**Final Drainage Report
U-Haul at Falcon
Falcon U-Haul Filing 1
El Paso County, Colorado**

Kiowa Project No. 21061

September 6, 2022

PCD File #
PPR-22-56

SHEET CONTENTS:
 DRAINAGE PLAN -
 PROPOSED CONDITIONS

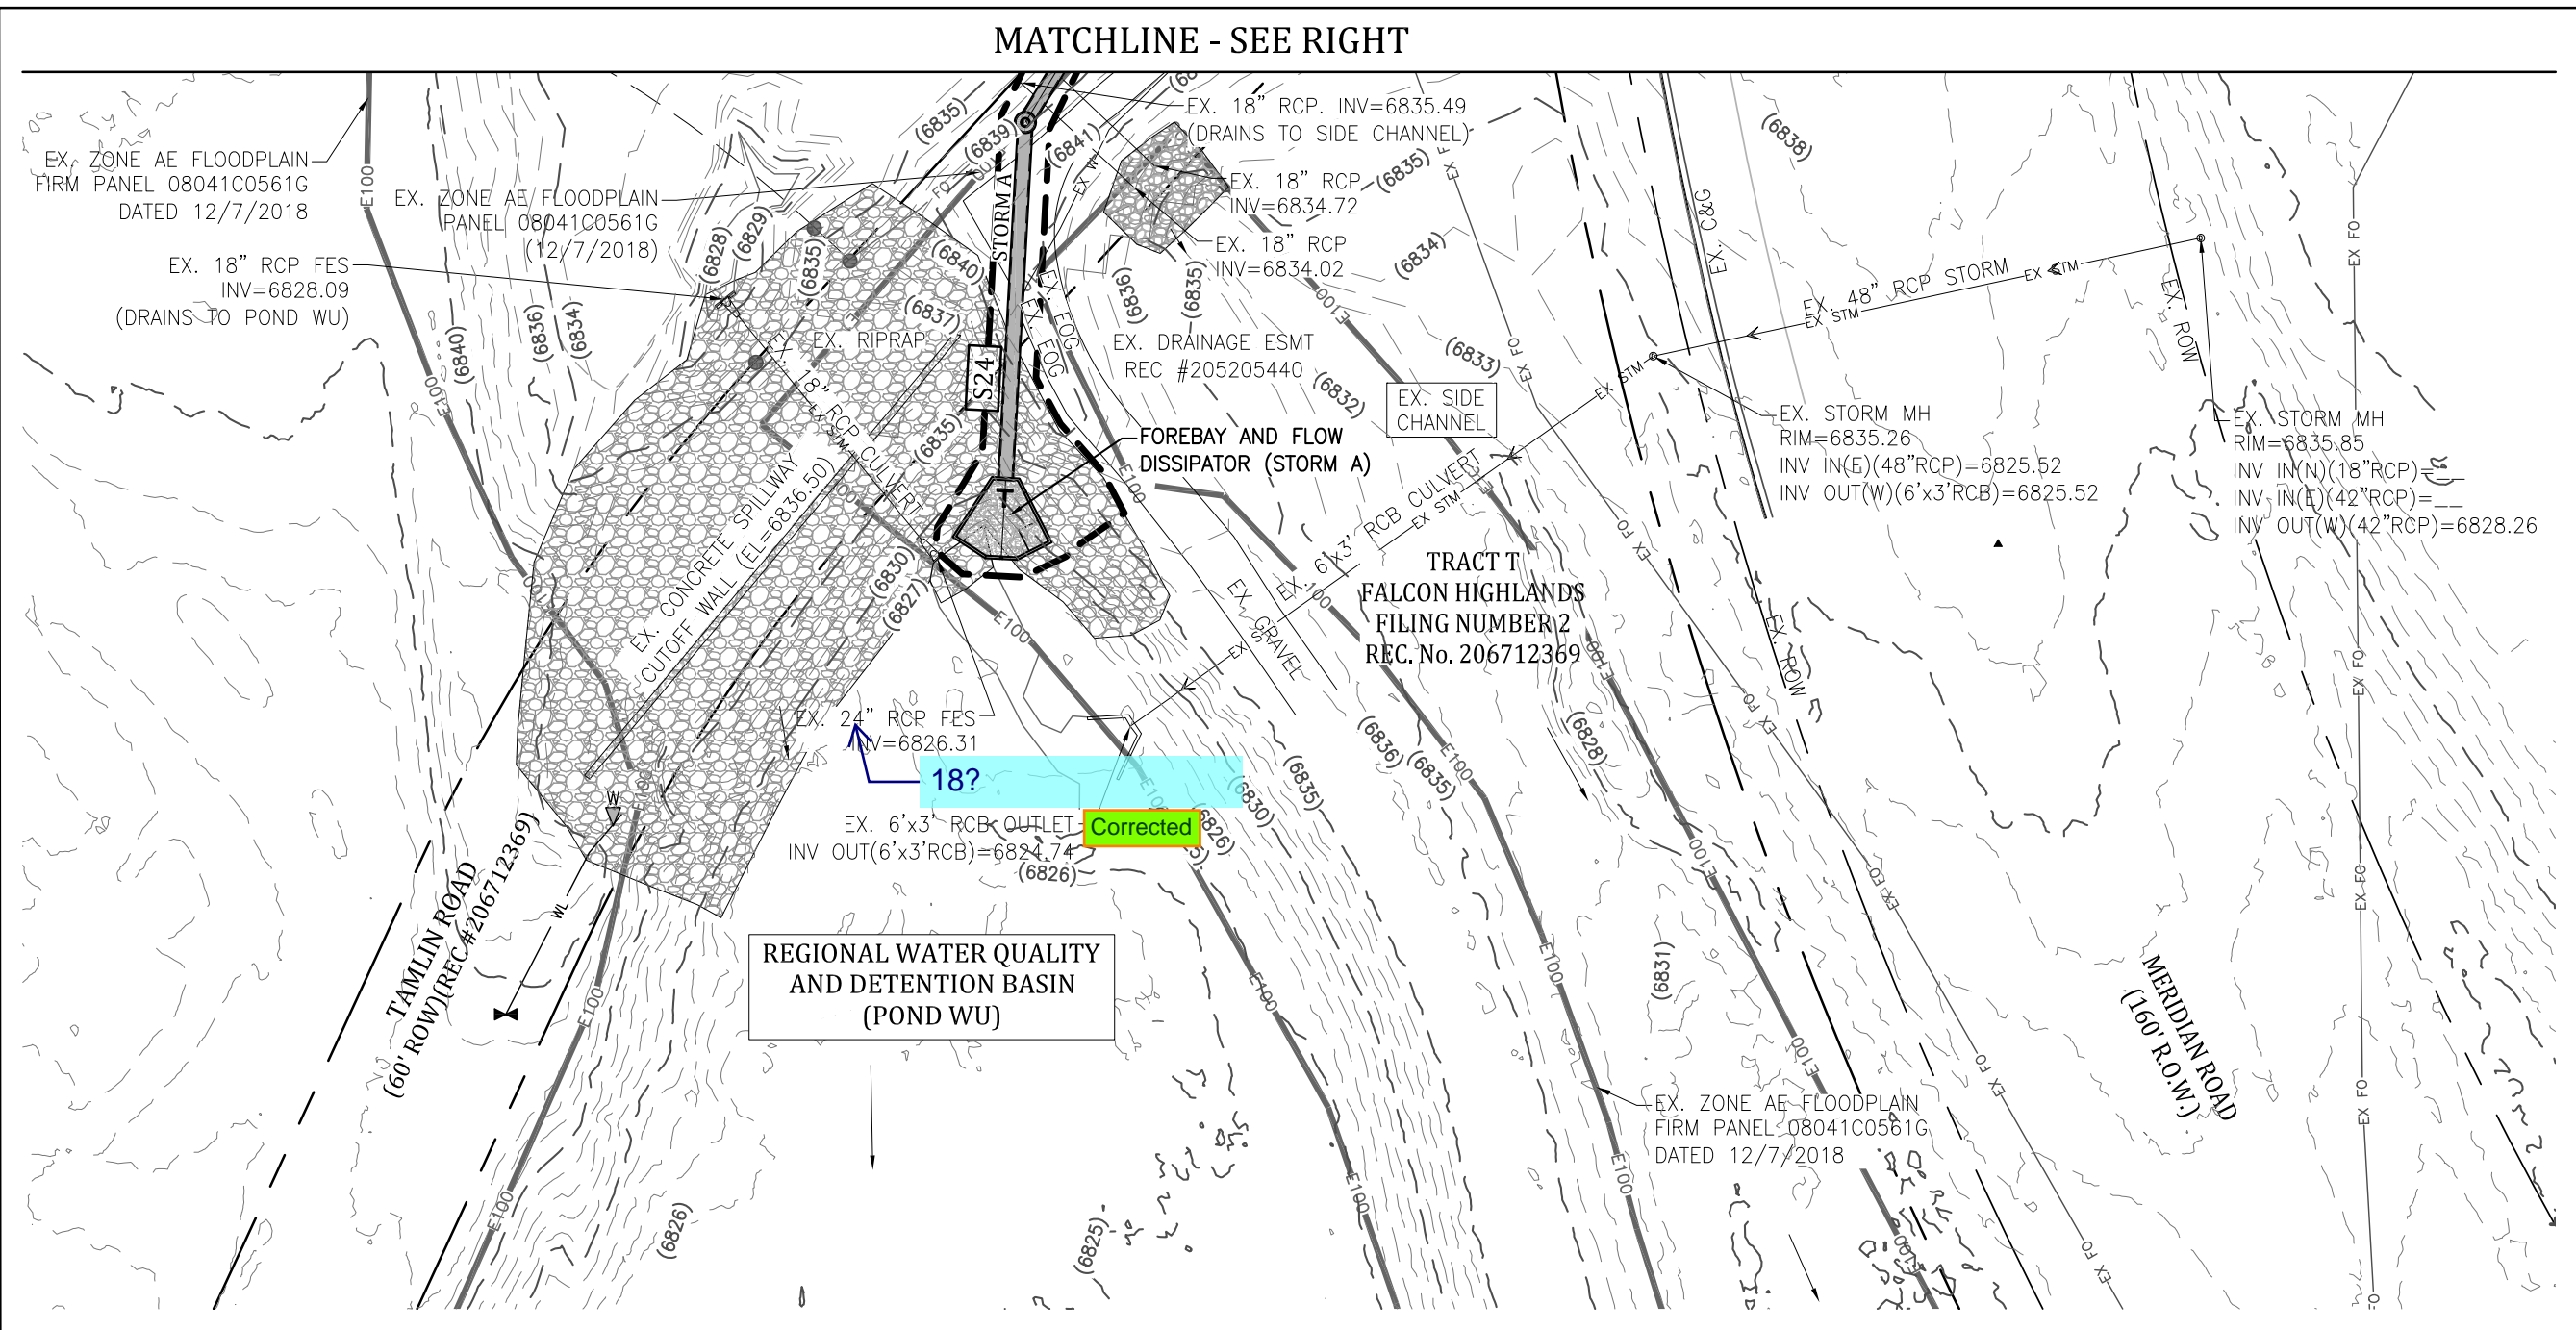
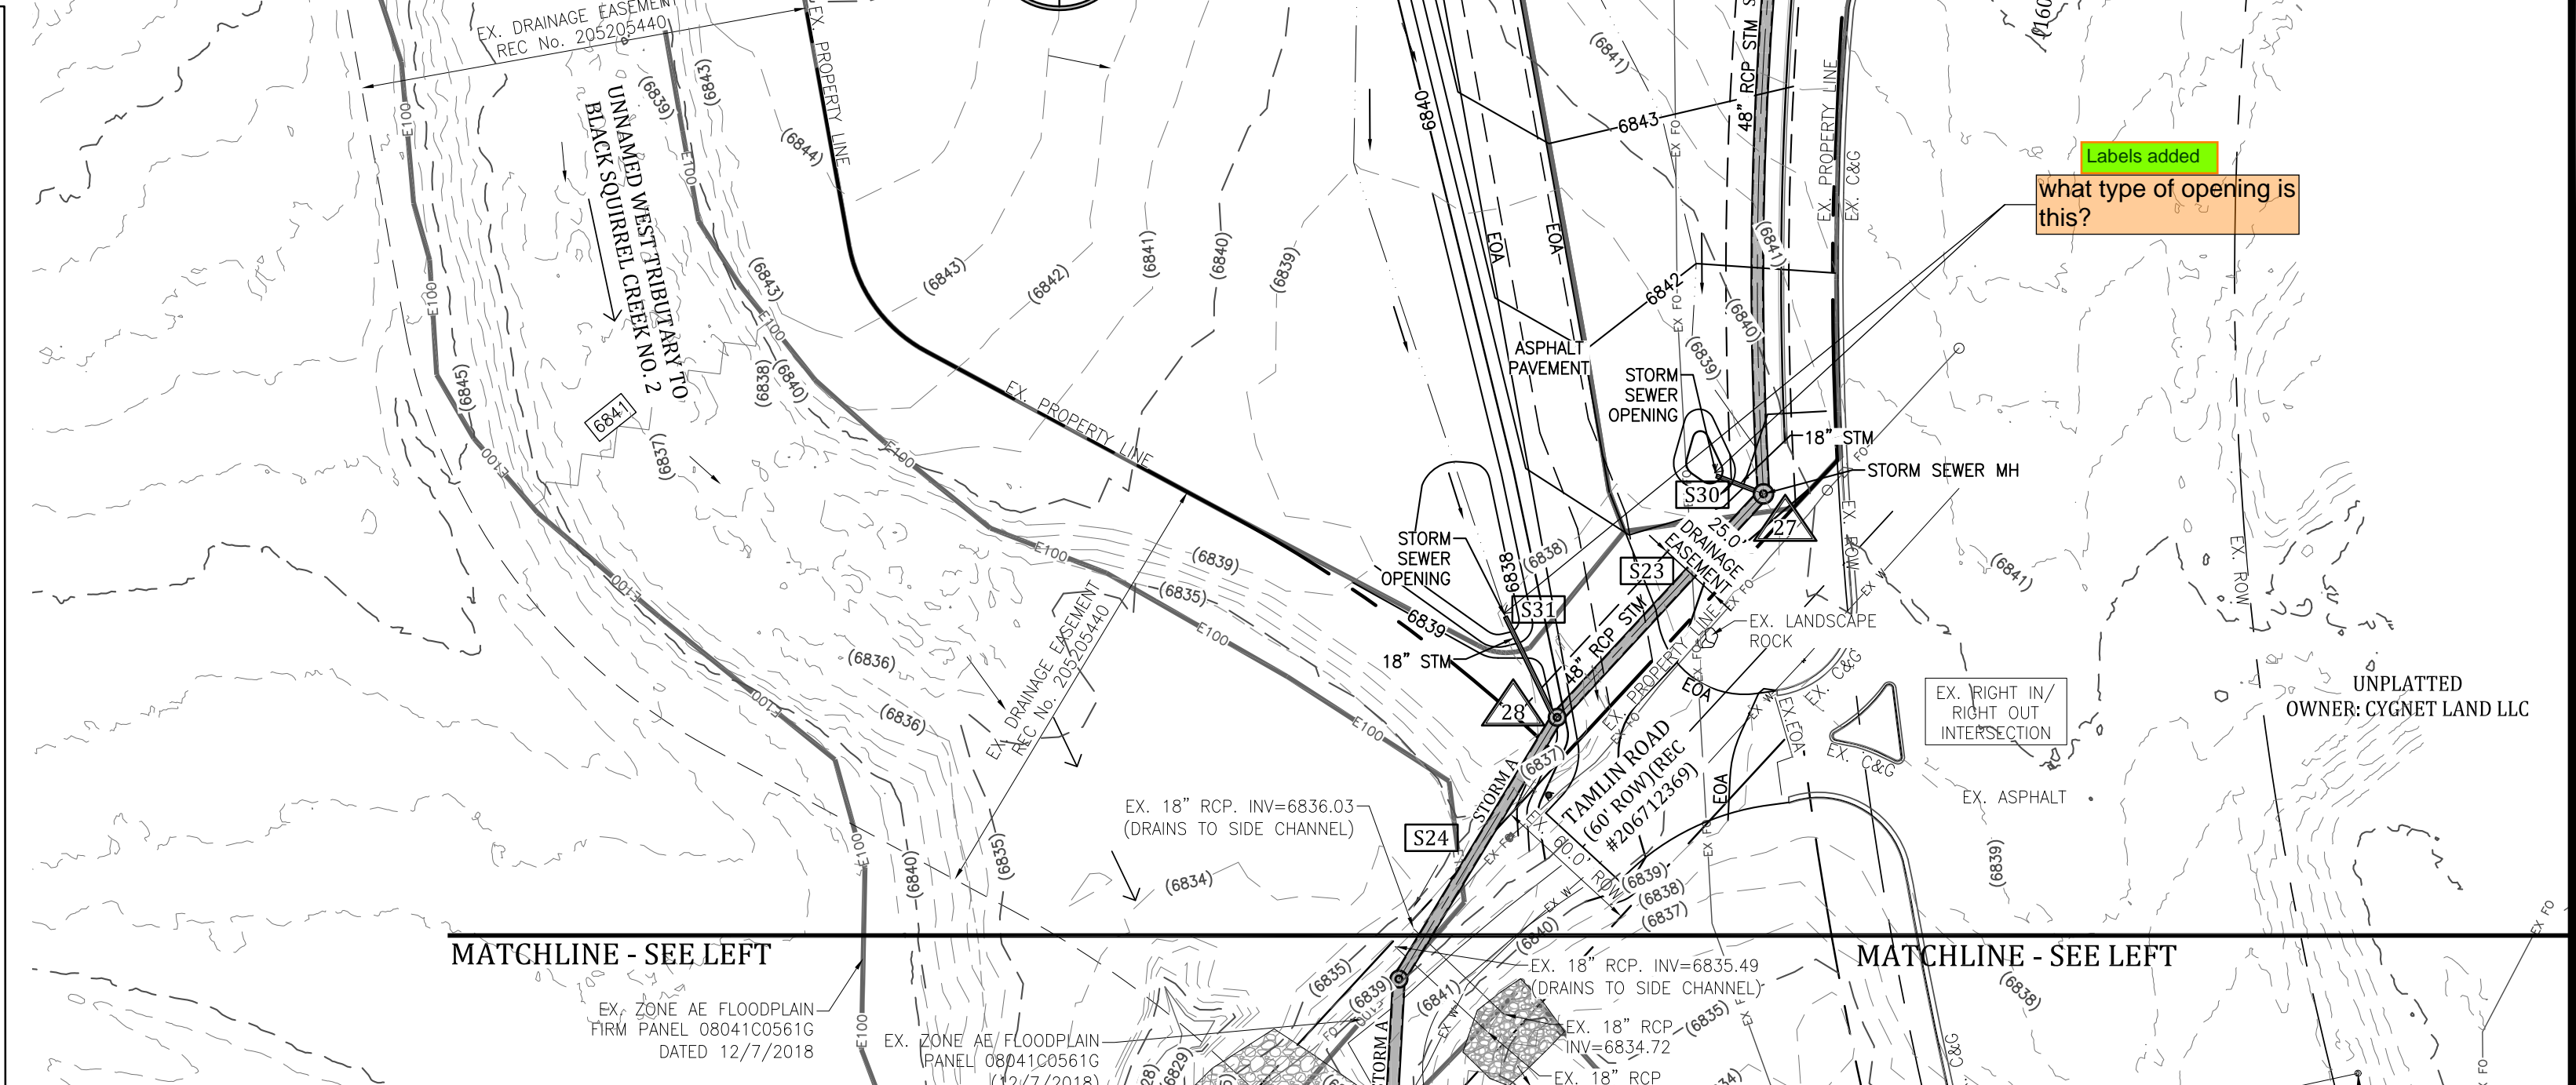
how will this portion of Basin A/D drain to DP1 and not to West Tributary?

Additional Basin added to show flows that are draining to the west tributary more clearly. It is less than 20% of the property.
